**Re: Animal Shelter ASDRC Response**

Friar Project #: 2022-060A

As requested, below is a summary of changes to Glastonbury Animal Shelter in response to the commentary that Friar Architecture received at the January 17<sup>th</sup>, 2023 ASDRC meeting:

GLASTONBURY ANIMAL SHELTER

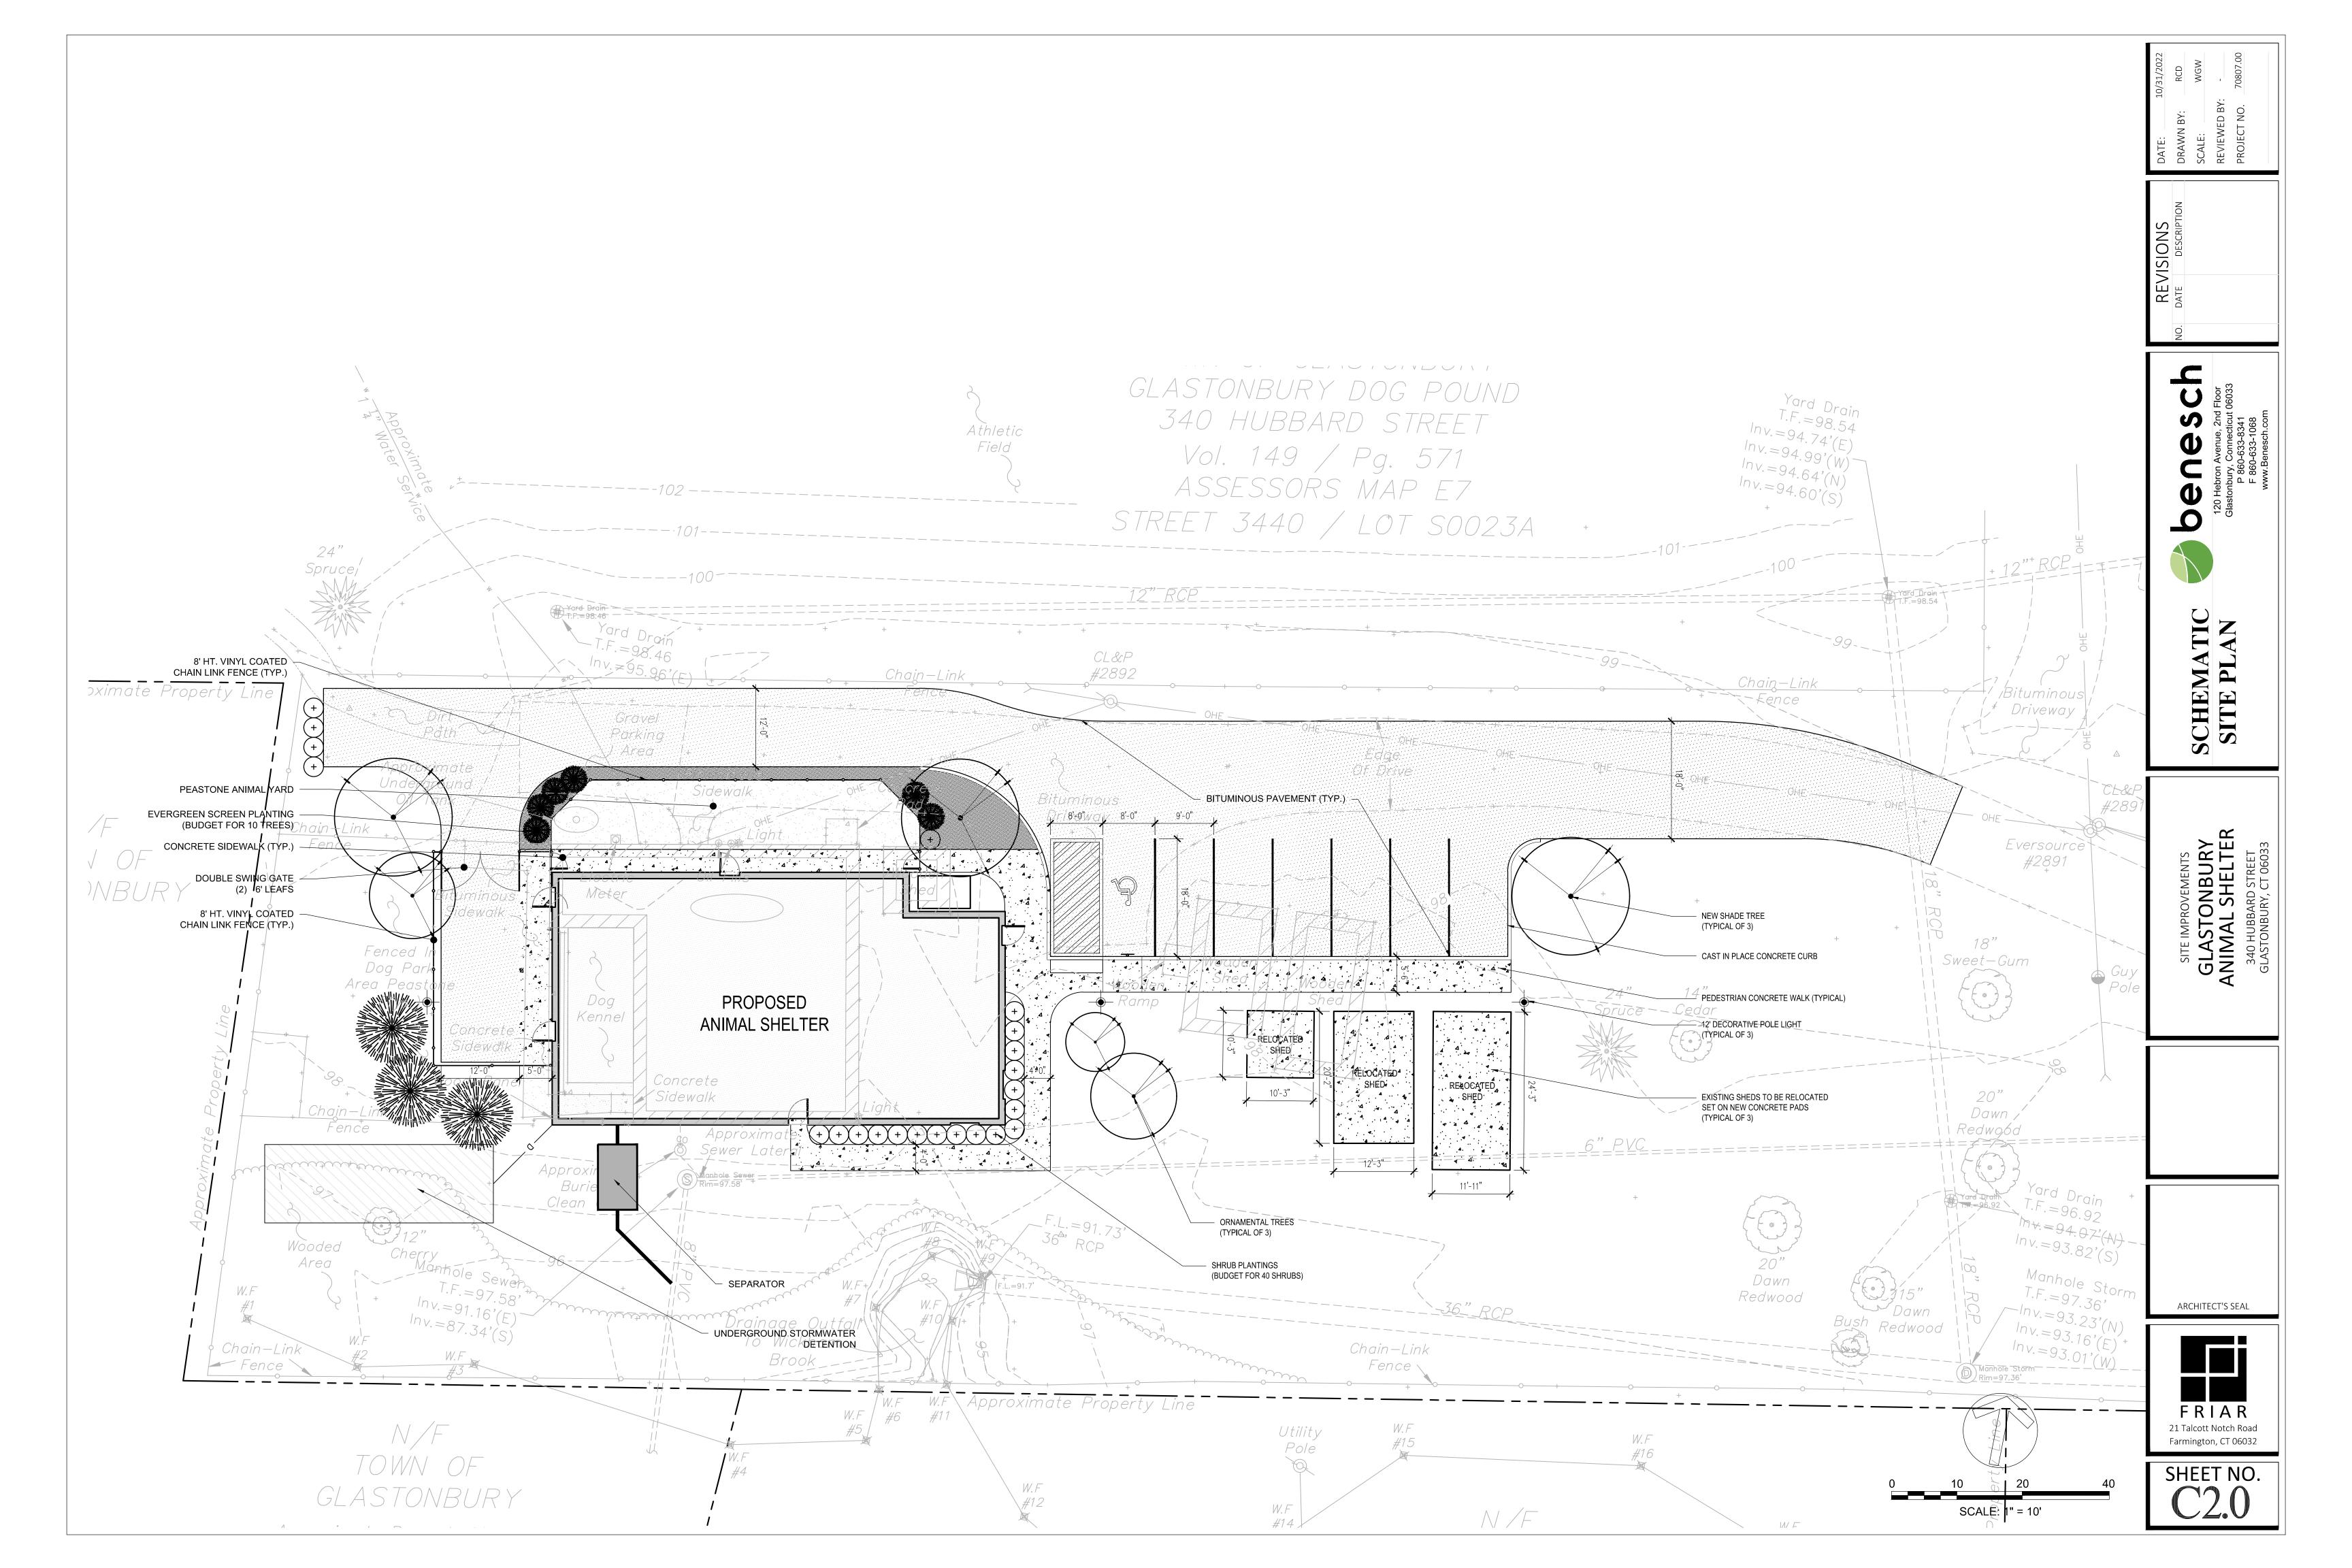
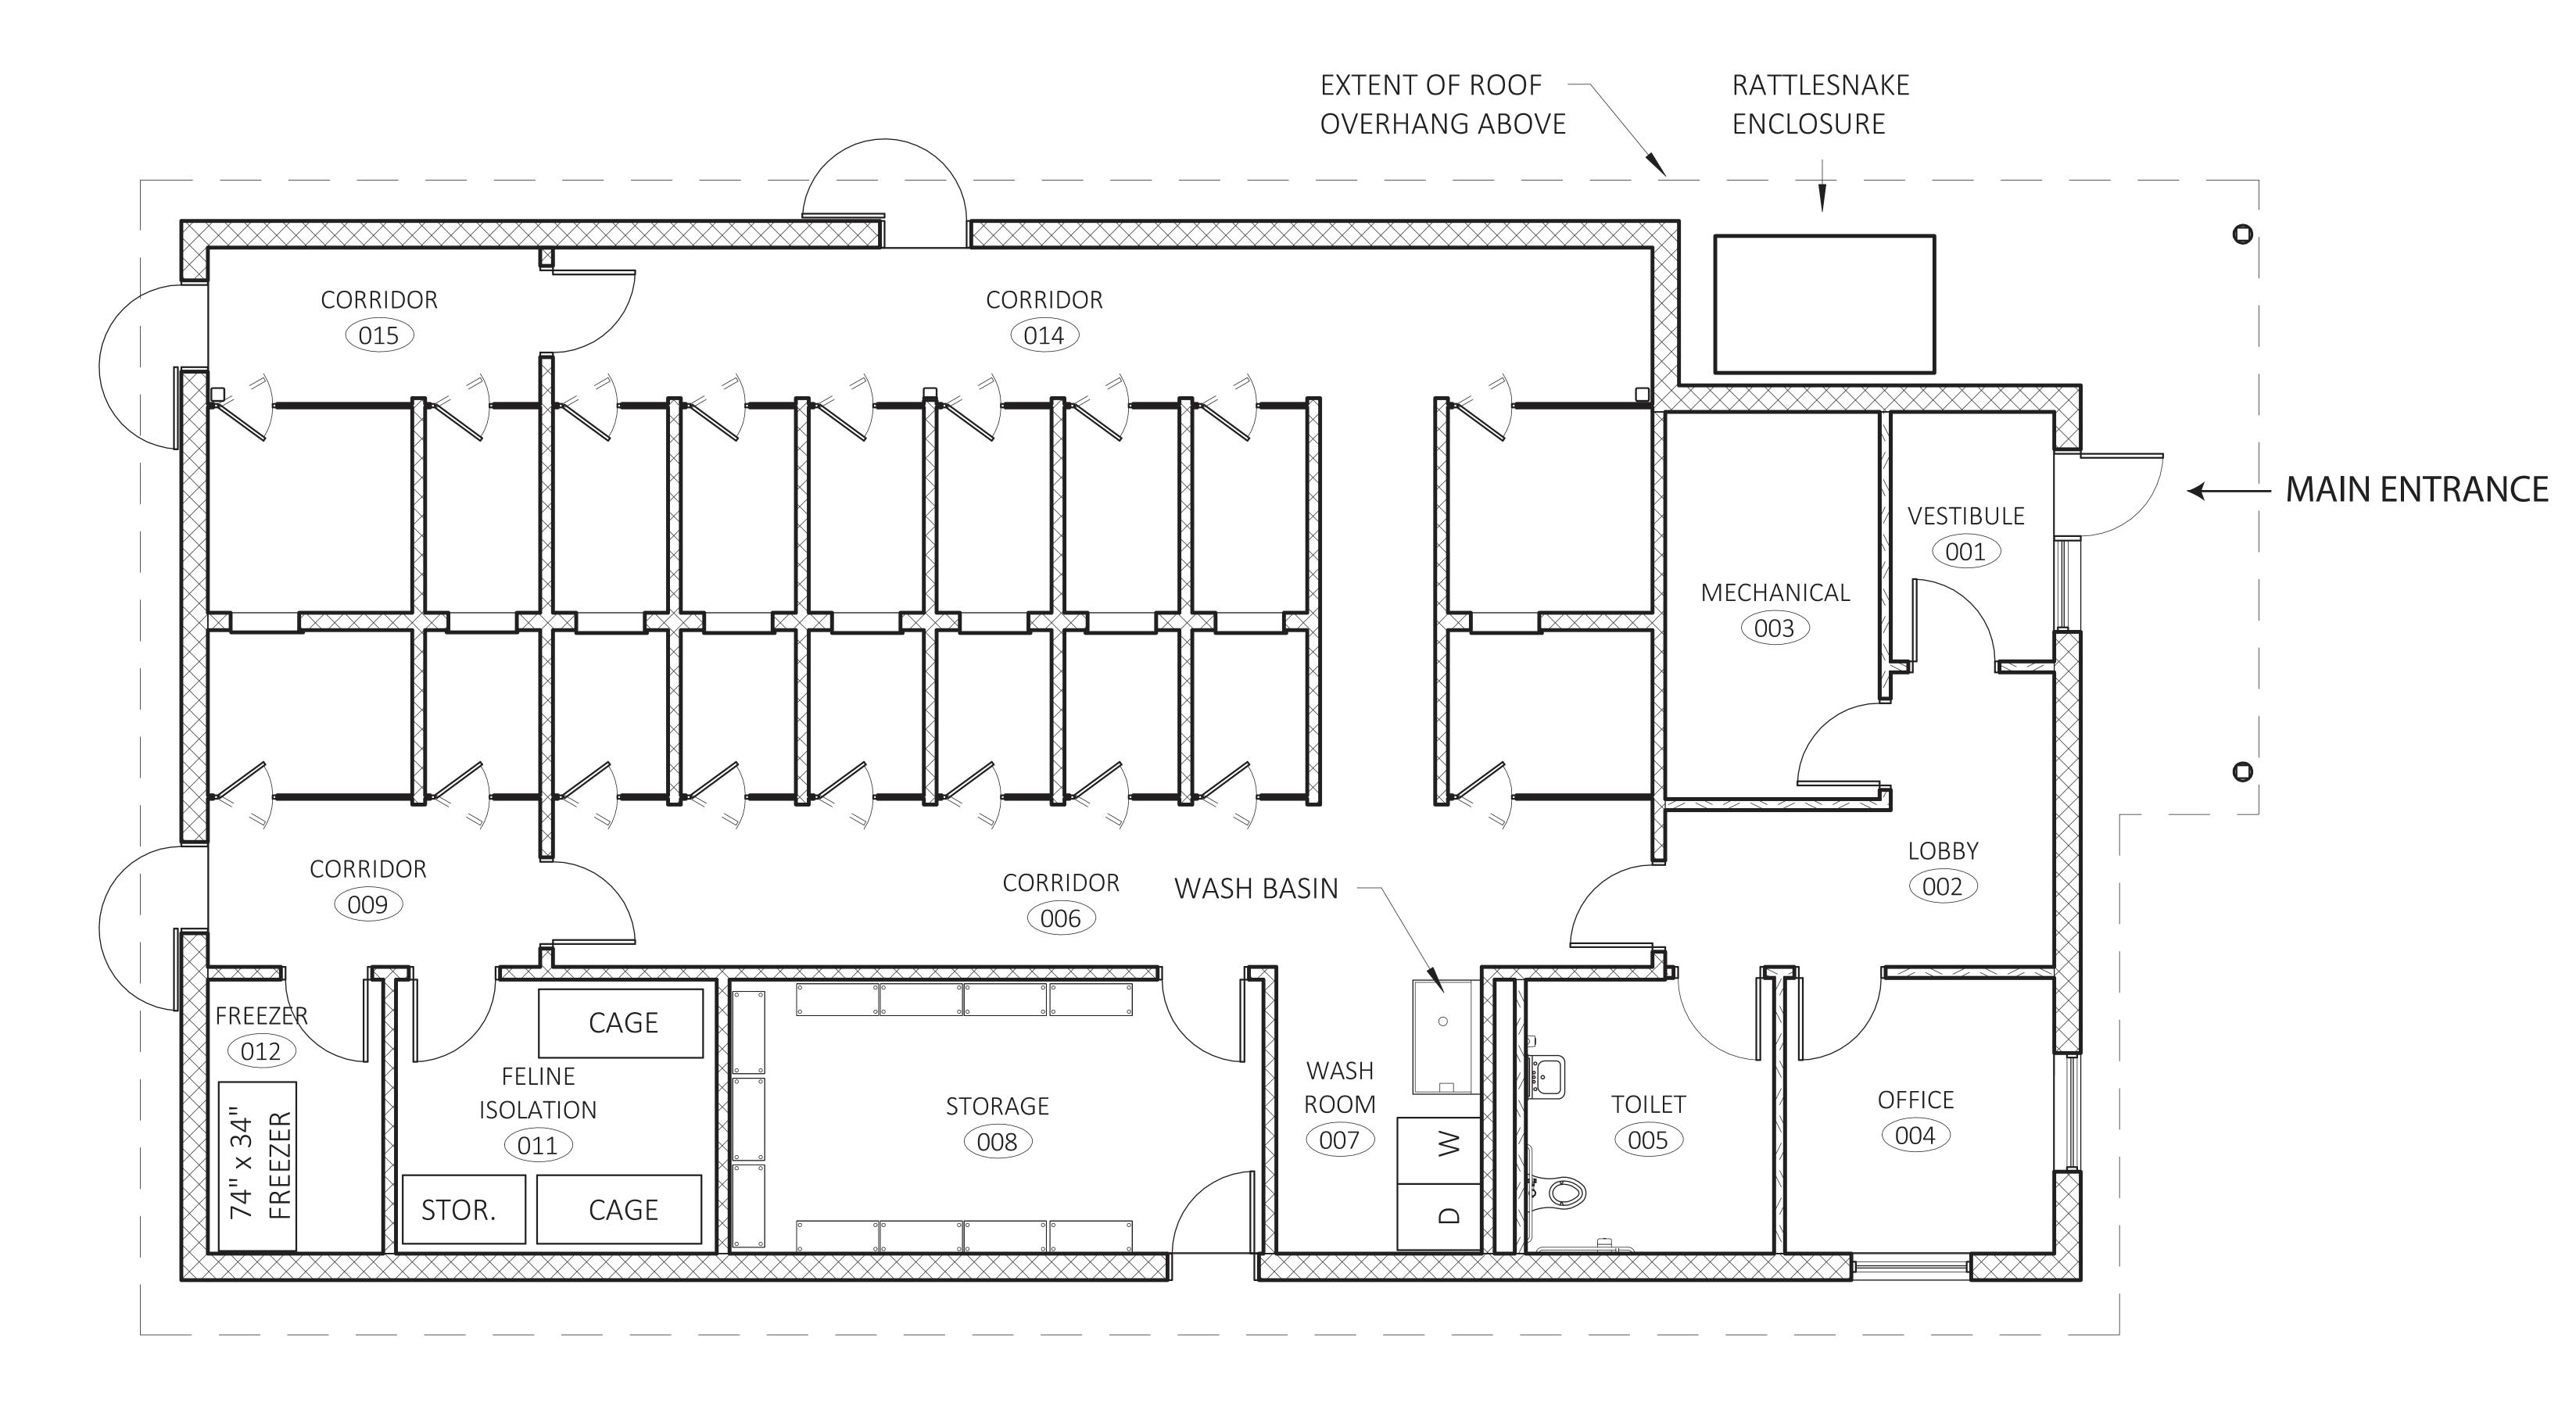
- Exterior CMU
  - Reduced height on north and east elevations. Replaced with a prefinished cementitious siding on metal stud backup above.
  - Changed all CMU material to one single color w/ a split face base to 32" above finished floor and ground face above.
- Window Fenestration
  - Revised the window locations and layout on the north elevation. Windows provided at kennel run corridor.
- Main Entry
  - Location of main entry defined further by locating the name of the facility above the entry portico. Main entry door changed to aluminum with glazed panels.
